Record of Executive Business and Chief Executive's Order

Reg. Reference: SD21A/0359 **Application Date:** 22-Dec-2021
Submission Type: Additional **Registration Date:** 14-Apr-2022
Information

Proposed Development: Construction of a residential development comprising 3 three to five storey blocks of 74 apartments (20 one bed, 48 two bed and 6 three bed) all with associated private balconies/terraces to the north/south/east/west elevations; vehicular and pedestrian access from Hayden's Lane to the north west of the site and closure of the second existing vehicular entrance at south west of site; pedestrian access from Griffeen Park to the south east of the site; provision of car and cycle parking, public and communal spaces, bin stores and all associated site development and clearance works, landscaping, boundary treatments and other servicing works.

Location: Hayden's Lane, Adamstown, Lucan, Co. Dublin

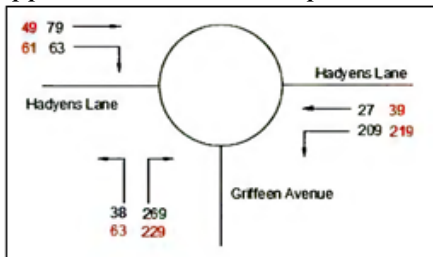
The applicant has proposed a raised pedestrian crossing at the intersection of Hansted Park and Hayden's Lane. They have not provided any details on the design of this crossing or the design of the access to Hansted Park. Due to the sub-standard condition of the footpath from the proposed development to the Hayden's Lane/Old Forge (The Avenue) junction, access to Hansted Park is essential to providing an adequate pedestrian link to services and public transport.
